PLANNING TECHNICAL REVIEW COMMITTEE –AGENDA

Re: Dover Heights (P-19-15)
Redevelopment of 1 First Street, Dover, NH
Technical Review Committee Minutes, Site Plan Review, March 7, 2019
KNA Project No. 17-1219-1

RESIDENTIAL SITE PLAN

DOVER HEIGHTS

MASTER PLAN
DOVER HEIGHTS
MAP 6 LOT 20
1 FIRST STREET
DOVER, NEW HAMPSHIRE
STRAFFORD COUNTY
PLANNING FILE # P19-16

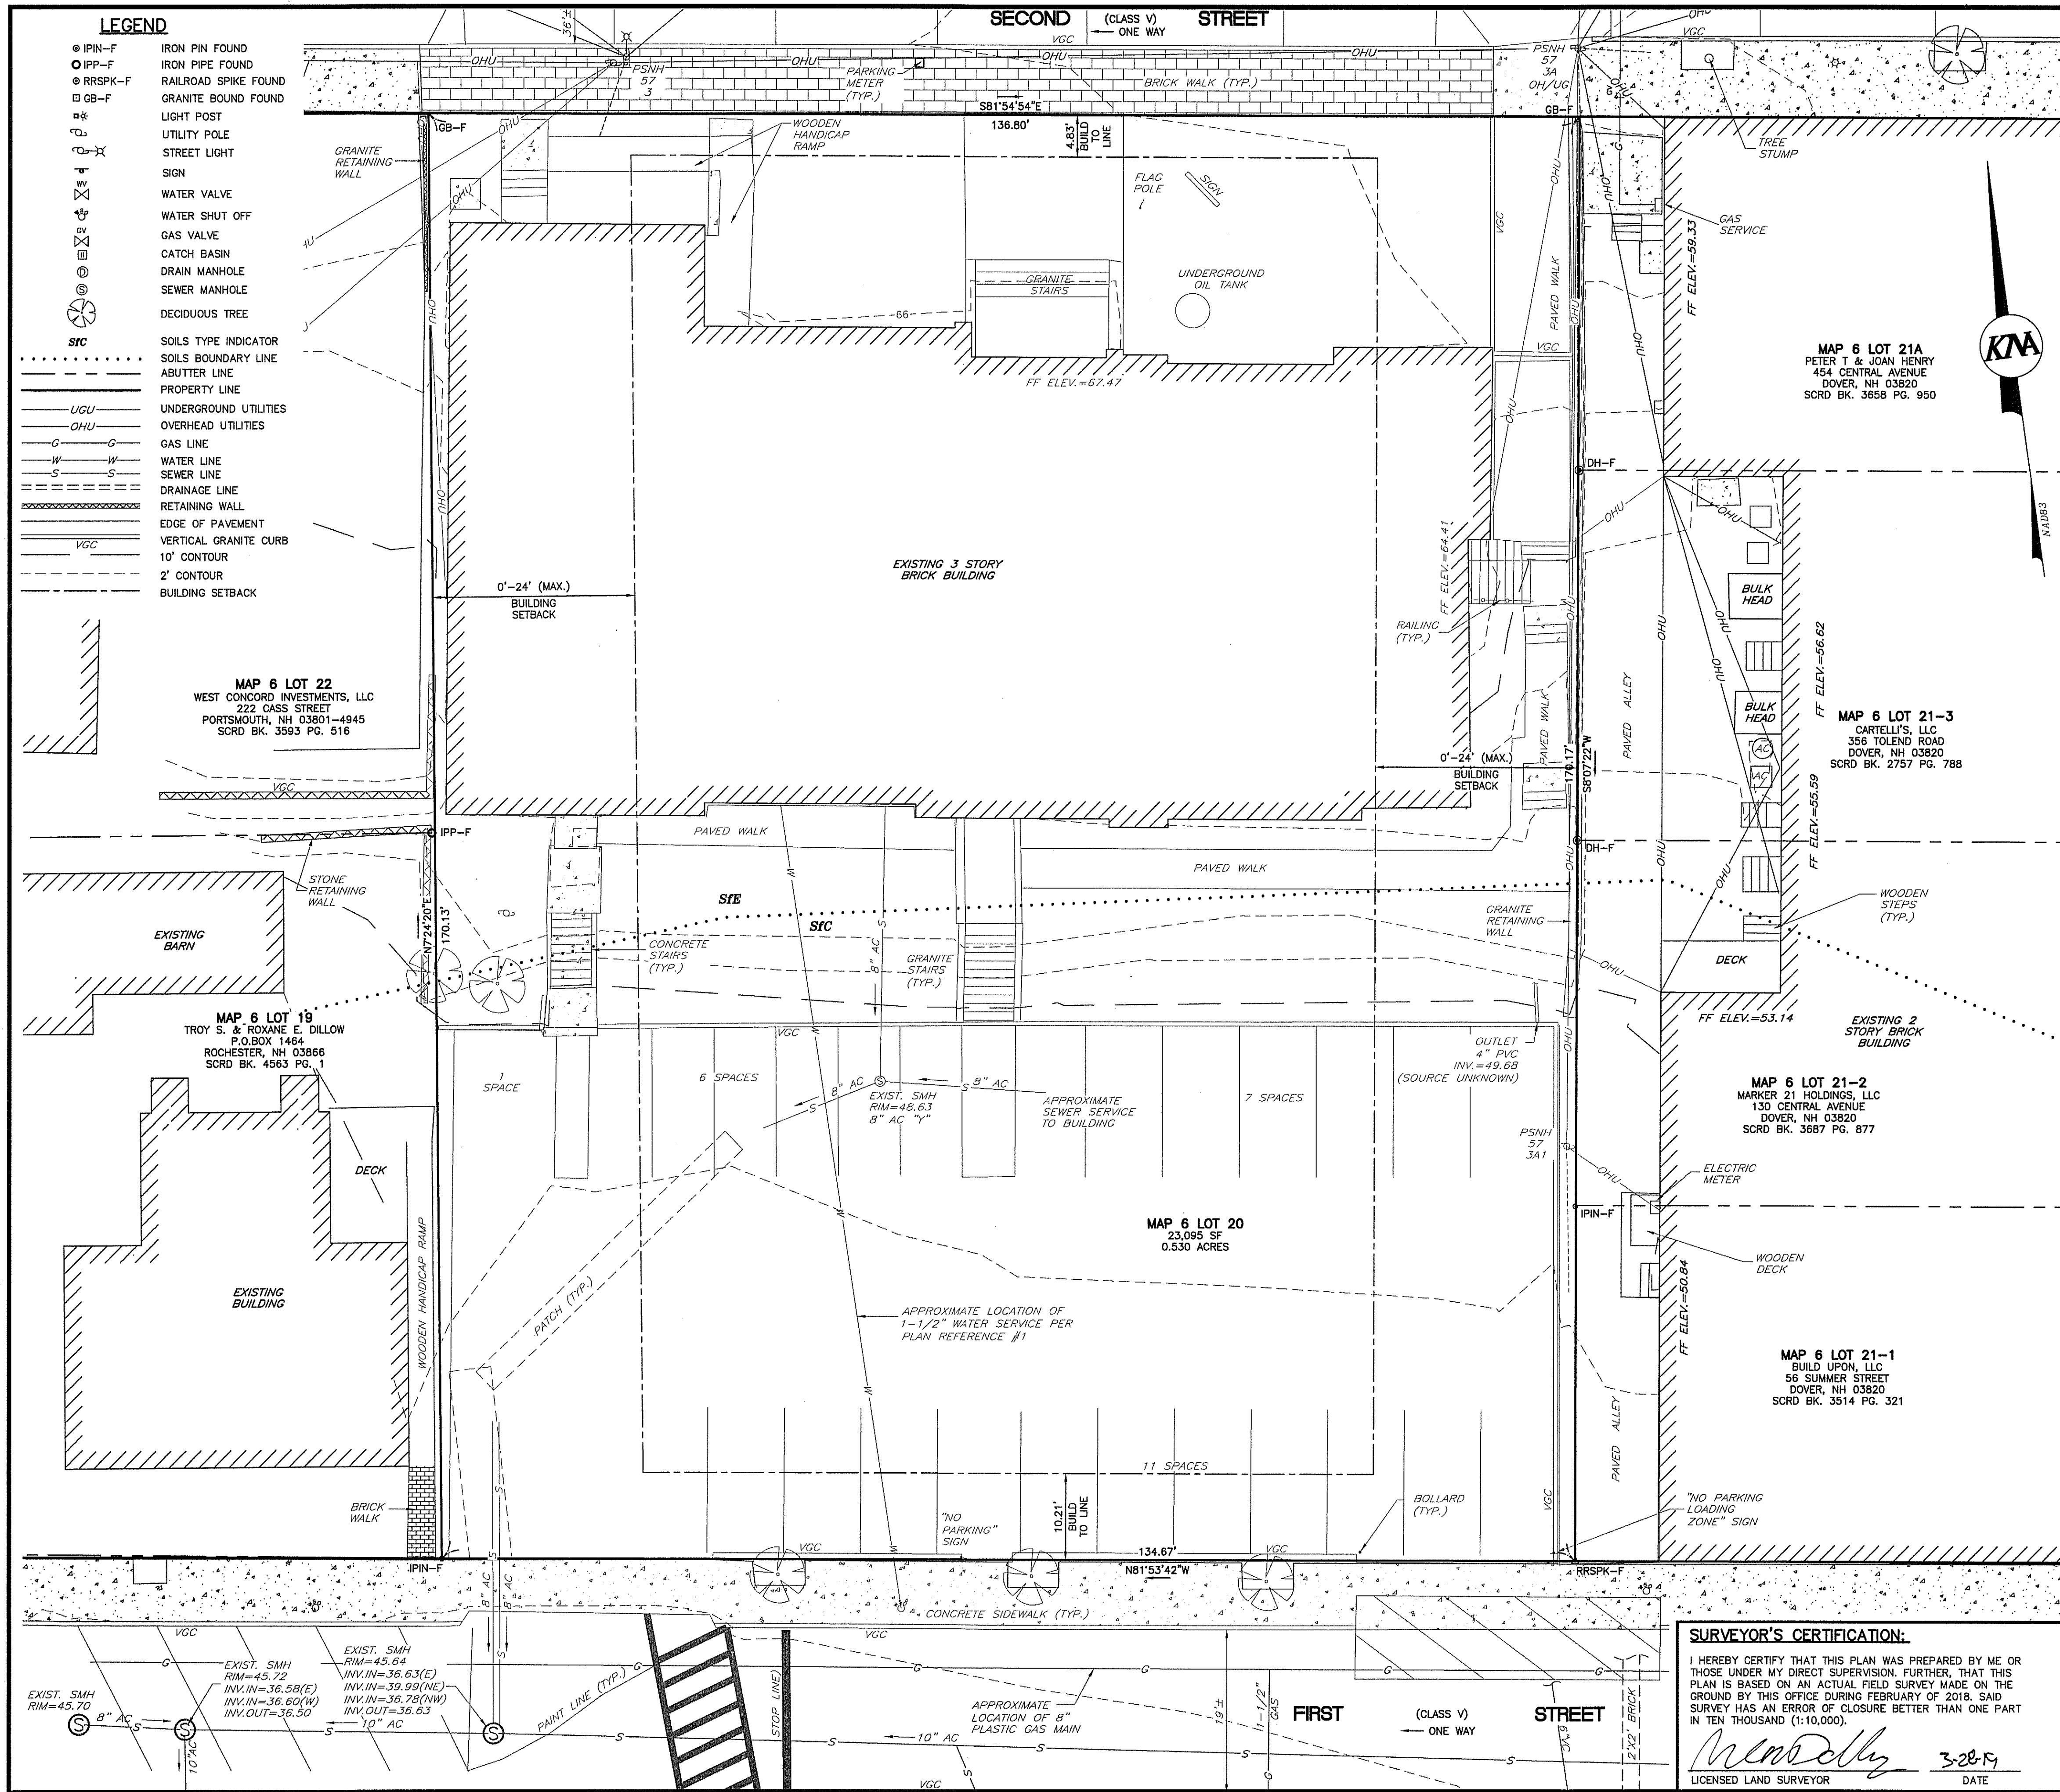
1. Impact Fees

- d. Add common site plan notes 6, 7, 11, 22, 23, 24, 26, 33.

- e. Add a note that this plan supercedes the previously approved plan (P16-15) for this site.
- Note 21 added to Master Plan (sheet 1).*
- f. Clarify bench locations/materials (provide detail if not granite).

Impact Fee calculation chart has been included on the Master Plan, Sheet 1.

- 7 - Temporary Construction easements are shown on Master Plan and discussed in note 17 (sheet 1).
 - 11 - Note 22 on Master Plan (sheet 1) added stating no wetlands on site.

- 26 - Note 24 added to Master Plan (sheet 1) and sign detail modified (sheet 14) to note hours of operation.
 - 33 - Note 21 added to Master Plan (sheet 1) regarding building addresses.

- Note 24 on Master Plan (sheet 1) has been added to reflect hours as stated on the Common Site Plan notes #26.*

Note 11 on Master Plan (sheet 1) updated to include NH RSA 155-a:5..

Note 19 on Master Plan (sheet 1) states that the contractor and owner shall coordinate access with the Fire Department prior to issuance of C.O.

SITE LAYOUT PLAN DOVER HEIGHTS MAP 6 LOT 20 1 FIRST STREET DOVER, NEW HAMPSHIRE STRAFFORD COUNTY PLANNING FILE # P19-16

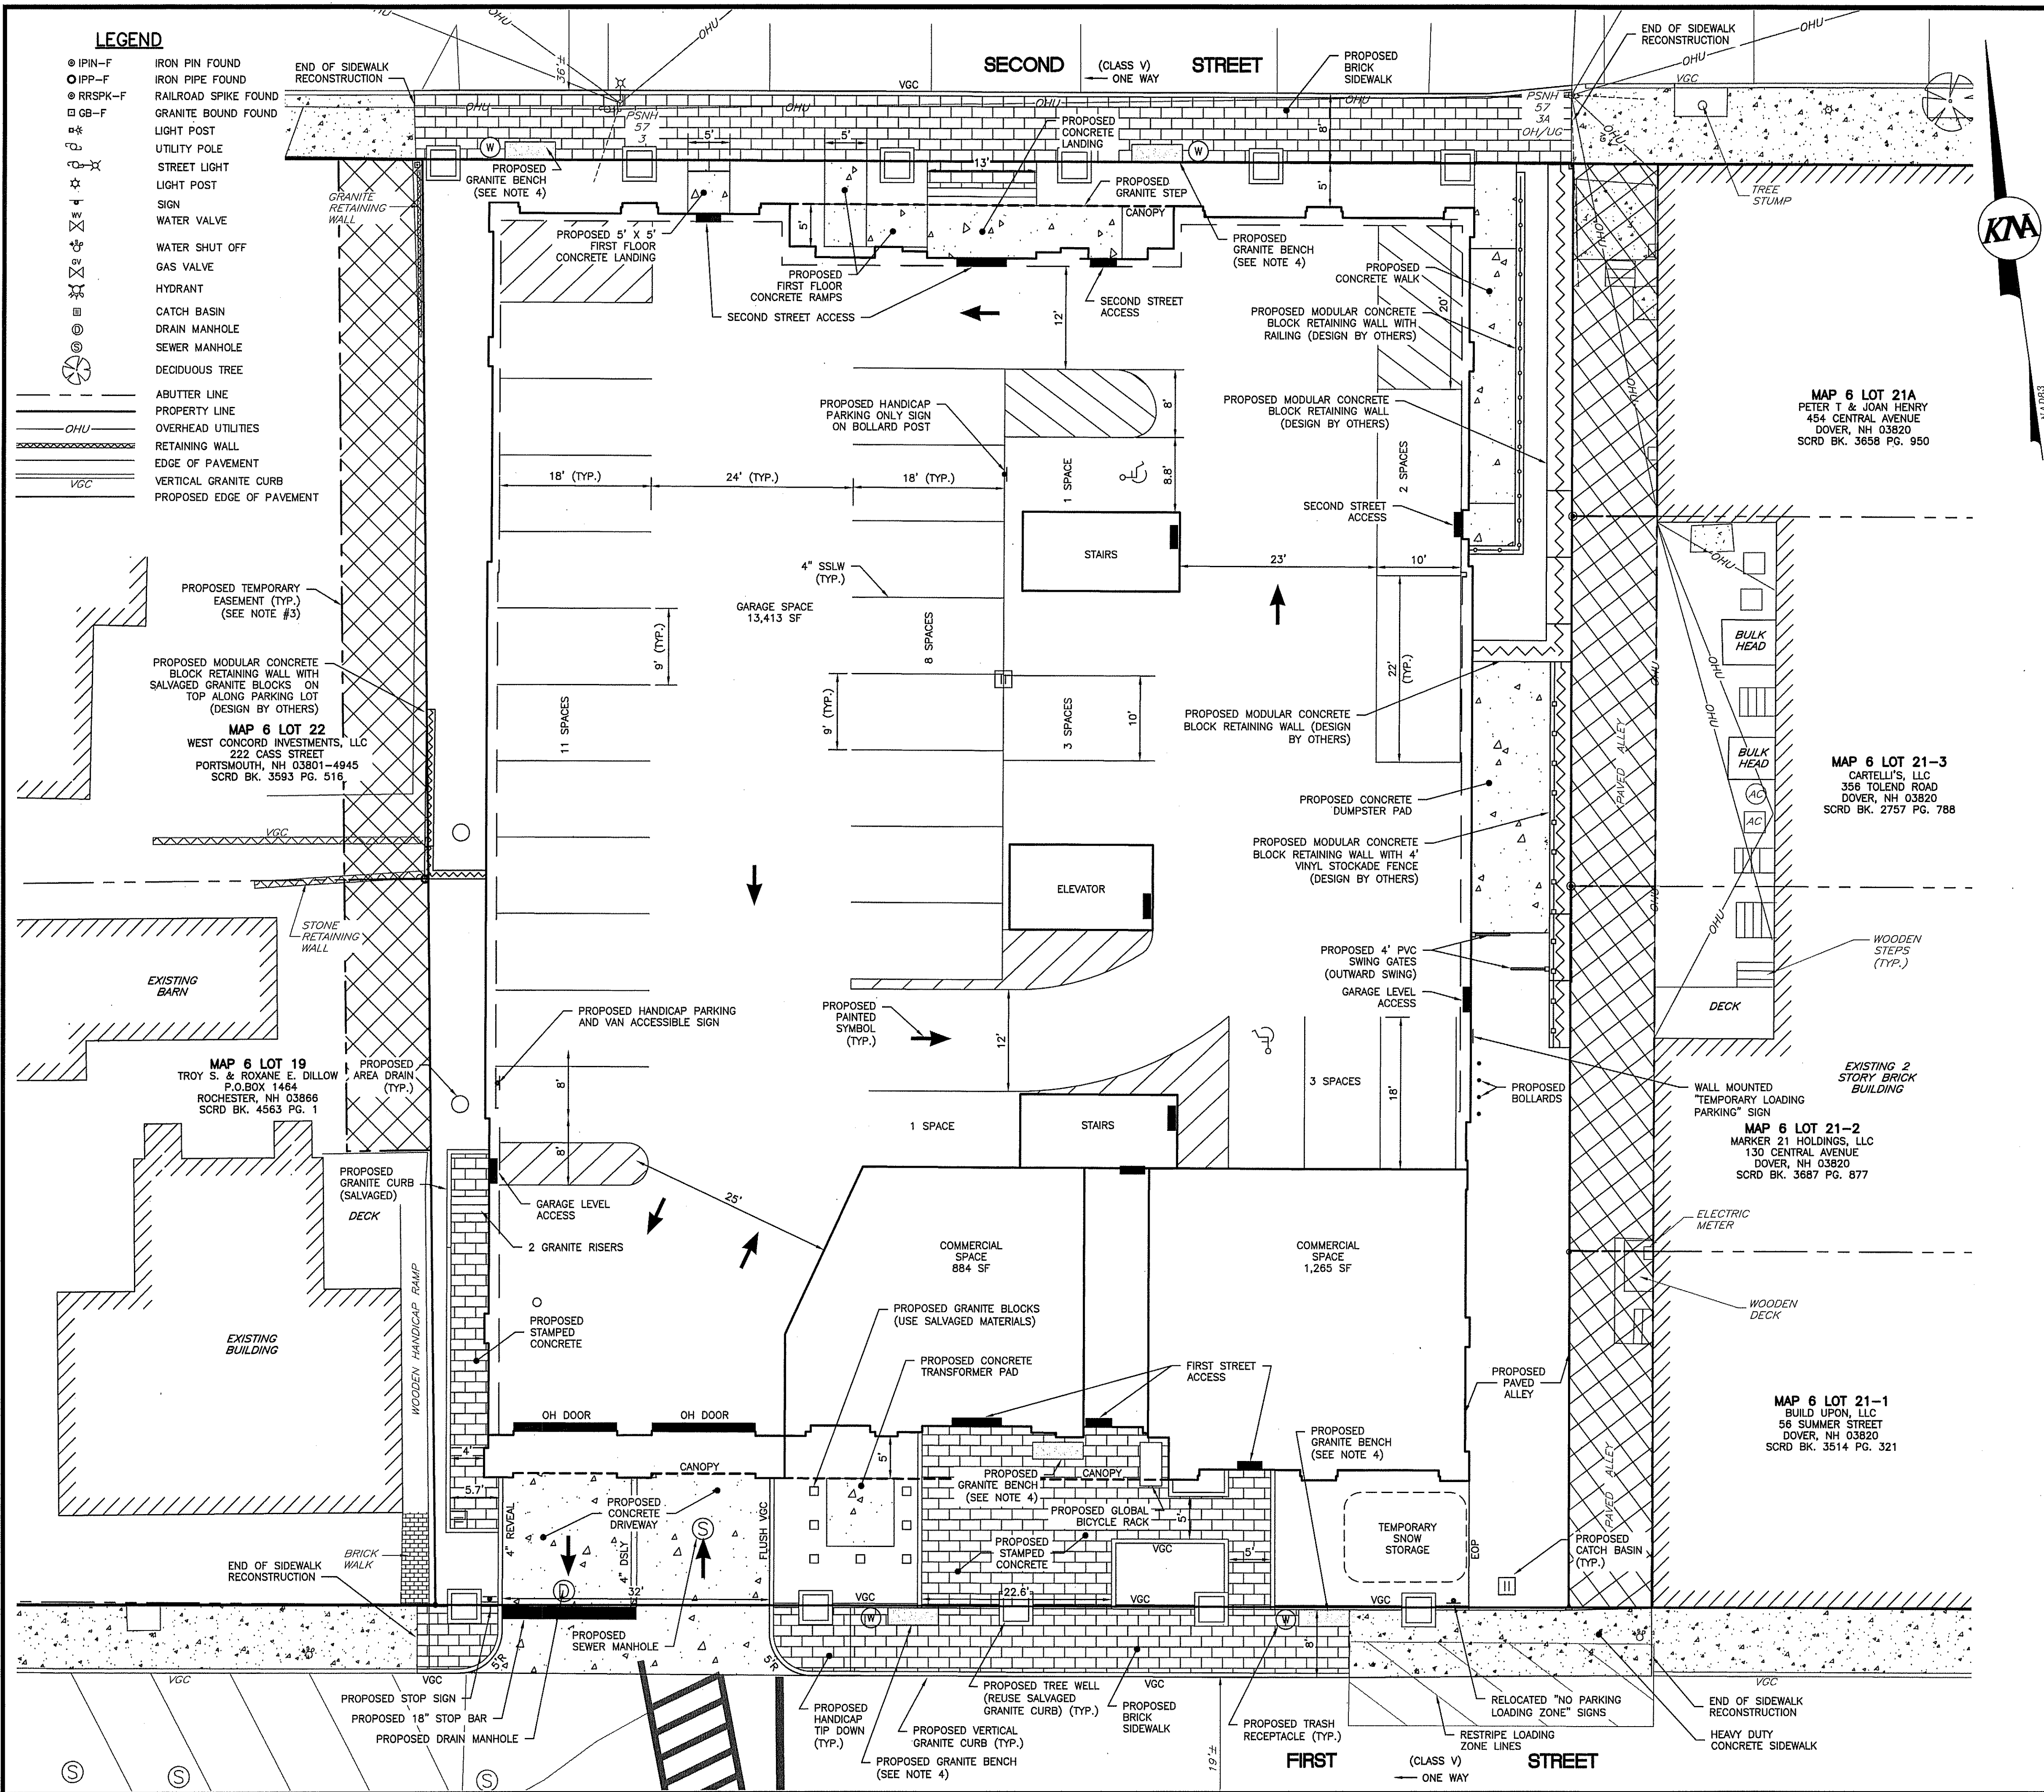
1. Plan sheet 4, clarify which utilities are exterior/interior.

4. Plan sheet 4 indicates overhead lines to be relocated. Sheet 7 does not appear to indicate underground electric distribution, please clarify.

5. Plan sheet 4 accessible space to be relocated closer to elevator in accordance w/ accessibility.

- All benches labeled and note 4 added on Site Layout Plan (sheet 4). Both a Granite Bench Detail and a Bench Alternate detail are in Construction Details (sheet 11).*

- g. Indicate brick sidewalk on First street on plan and rendering.
- First Street sidewalk changed to brick and noted on Site Layout Plan (sheet 4)..*
- h. Indicate trees will meet minimum 3.5" caliper.

Wall mounted sign shown on Site Layout Plan and sign detail added to Construction Details sheet 11.

The accessible space next to the entrance has been moved next to the stairwell, which is close to the elevator.
